Intermodal Logistics Centre at Enfield

MODIFICATION APPLICATION

ILC –E – PT3A – Modification Application No. 3
REV A

31 August 2009

FIGURE 2 SITE LAYOUT

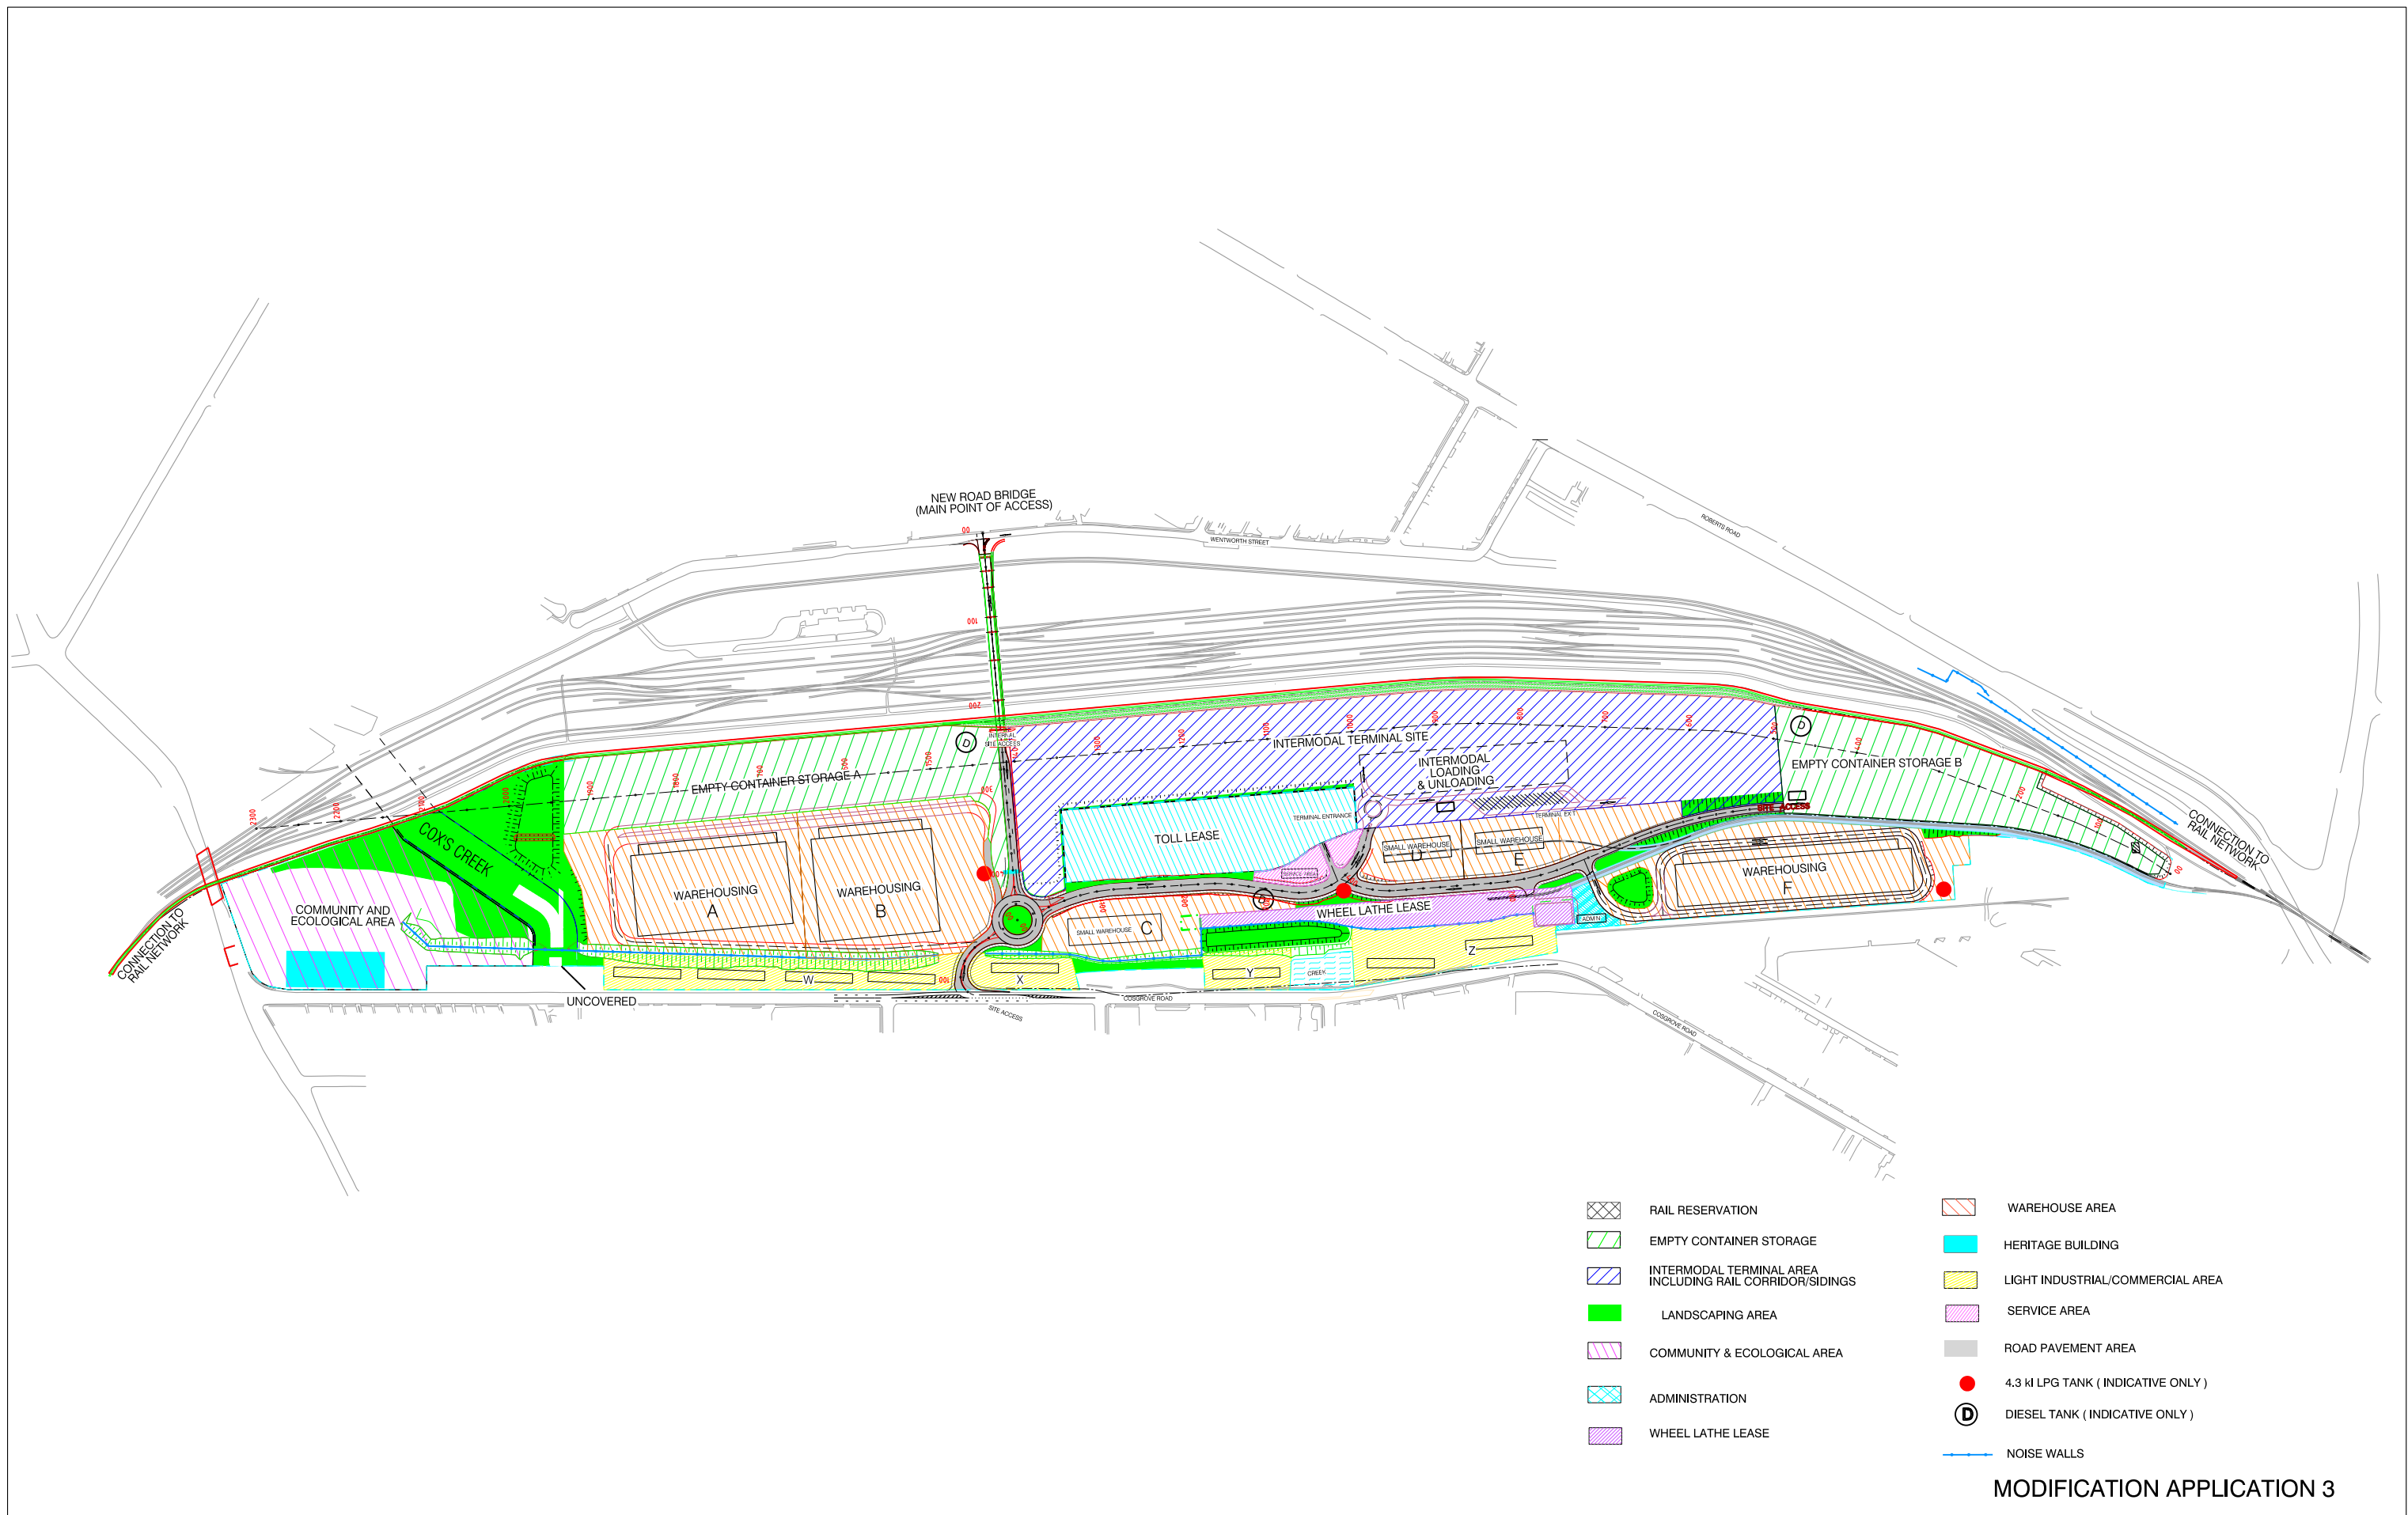
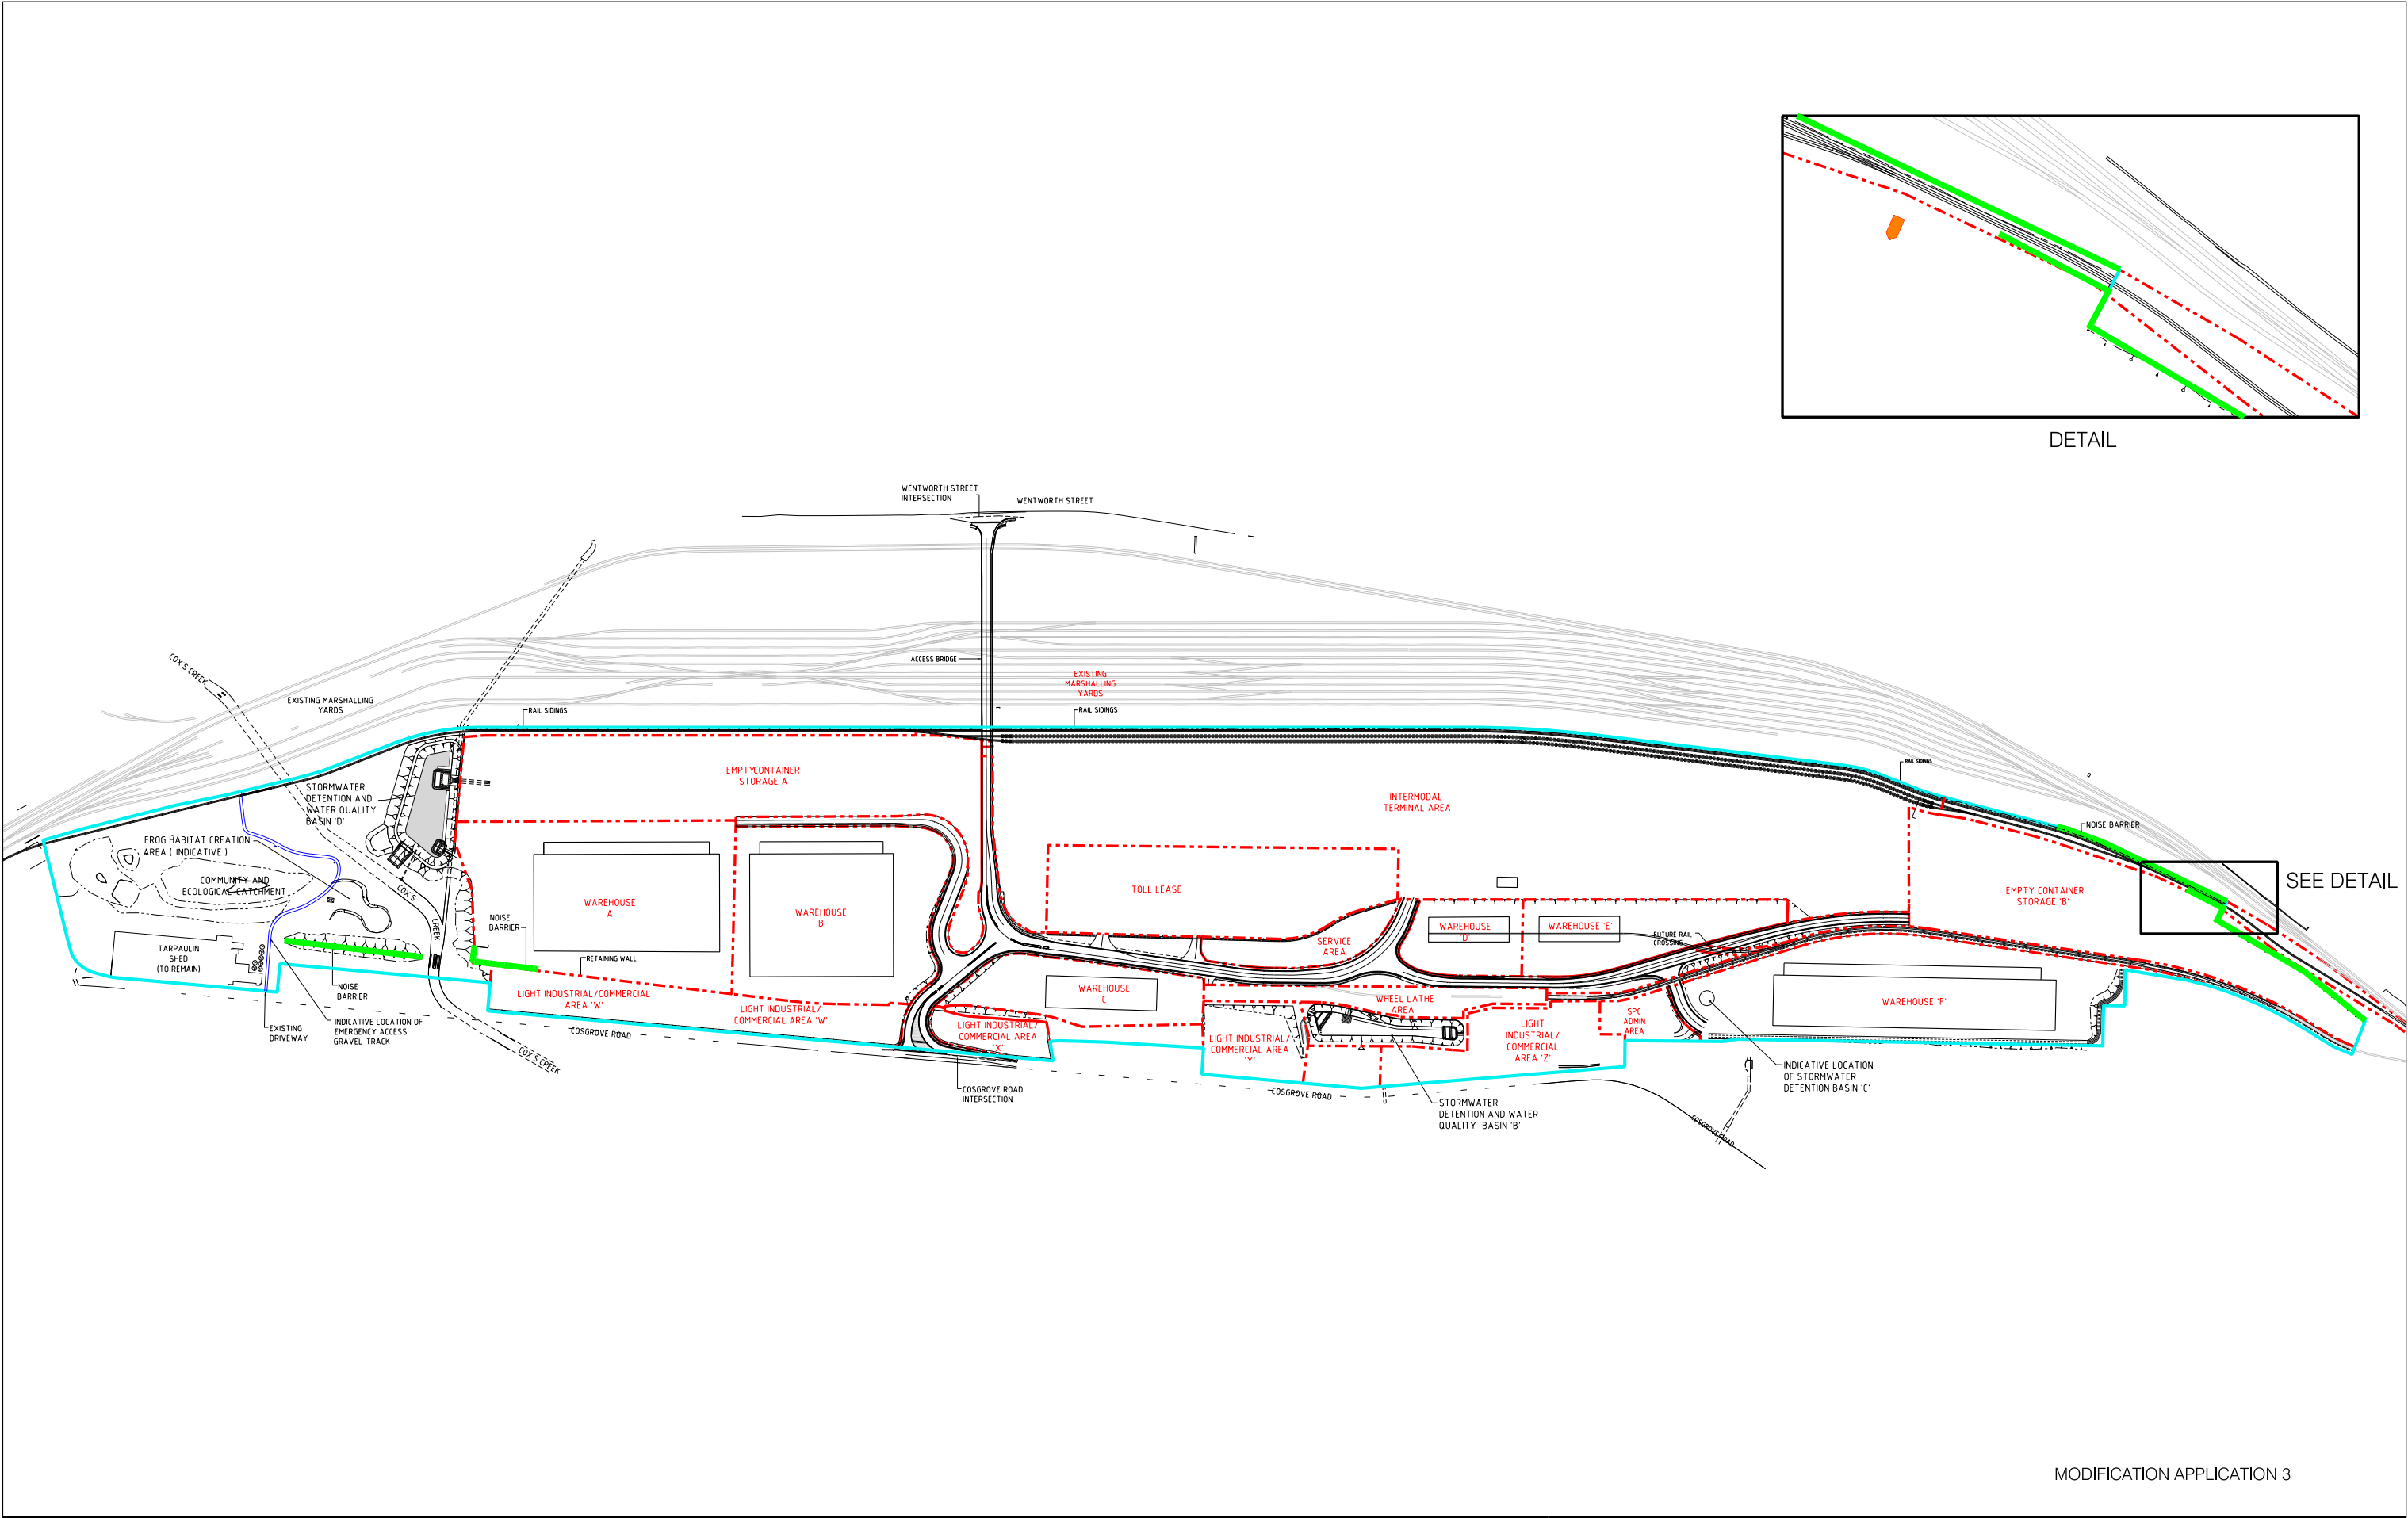
Sydney Ports proposes to relocate the northern noise wall east of the approved location to a location on the boundary of the ILC Site and RailCorp's New Marshalling Yards, as shown in Figure 2.

As for the approved noise wall, the proposed noise walls would be 5 m in height above the existing ground level. It would involve two overlapping noise wall sections totalling no less than 375m in length and would be located along the western boundary of Empty Container Storage (ECS) B within the ILC Site. One section will run approximately 195 m south from the northern-most point of ECS B and other section would run a further 178 m to the south. Each section will be contiguous and free from openings and gaps.

A noise wall 1.8 m high on top of an earth mound approximately 2.5 m high (total noise barrier heights of 4.3 m) is proposed in the south-east of the ILC Site, as shown in Figure 2. The proposed noise barrier would extend from the southern part of Coxs Creek towards the Tarpaulin Shed.

The noise barriers in the east of the Site, north of Coxs Creek, have been modified to include the following (refer also to Figure 2):

- A 5 m high L-shaped (in plan) noise wall 80 m in length at the south-eastern corner of the Warehouse A hardstand area. The barrier will be located 60 m to the north and

20 m to the west of the corner of the hardstand area. The barrier will be contiguous and free from openings and gaps.

- Stacked shipping containers (10 containers long by 4 containers high) at the south-eastern and south-western perimeters of ECS A, whenever reach stacker operations are occurring in ECS A.

Consequently, noise barriers along the eastern part of the site (see above and Figure 2) have been modified to protect the residential area located to the south-east of the ILC site, with no noise walls proposed along the eastern part of the site to the north of Warehouse A.

The detailed design has resulted in improvements in the internal road layout as shown in Figure 2. In general, changes in the internal road are considered minor and generally consistent with the approved layout. The internal road improvements are listed below.

The Cosgrove Road exit lane has been split from the entry lane via a concrete median and a merge taper to the north created for the exit lane. This allows exiting vehicles to be parallel with Cosgrove Road prior to merging, which will allow them to use their rear view mirrors to check for northbound traffic.

The originally approved central roundabout has been replaced with a combined Y and T intersection. The new 'T' junction (Cosgrove Road access and IMT/Overbridge access)

- Minor changes in the internal road layout routes as shown in Figure 2. For example, a section of the main intermodal access road has been moved marginally to the east so that it is located adjacent to the existing Wheel Lathe lease.
- Driveway access for the existing Toll lease area has been changed. The original access road to the north of the lease area has been deleted and two new driveway accesses have been added to connect to the existing southern-most driveways.
- Changes have been made to the widths of the internal roads and to the radii of the kerb returns to allow for B-Double turning movements throughout the Site. This will ensure that B-Double swept paths for left hand turns do not cross the oncoming traffic lane.
- A driveway for Sydney Ports' Administration Area has been added and the location of the driveway for the wheel lathe area has been relocated to the south.

The existing access track will be gravelled (Figure 2). Sydney Ports and its rail stakeholders (namely Australian Rail Track Corporation and RailCorp) are currently preparing a Development Deed which will identify the terms and operational protocols for use of the access track.

Sydney Ports requests that Condition 1.1 of the Project Approval refer to the modified noise wall arrangement discussed in this document and shown in Figure 2.

Sydney Ports requests that Condition 1.1 of the Project Approval refer to the improved ILC Site layout, including the internal road layout, presented in this document and on Figure 2.
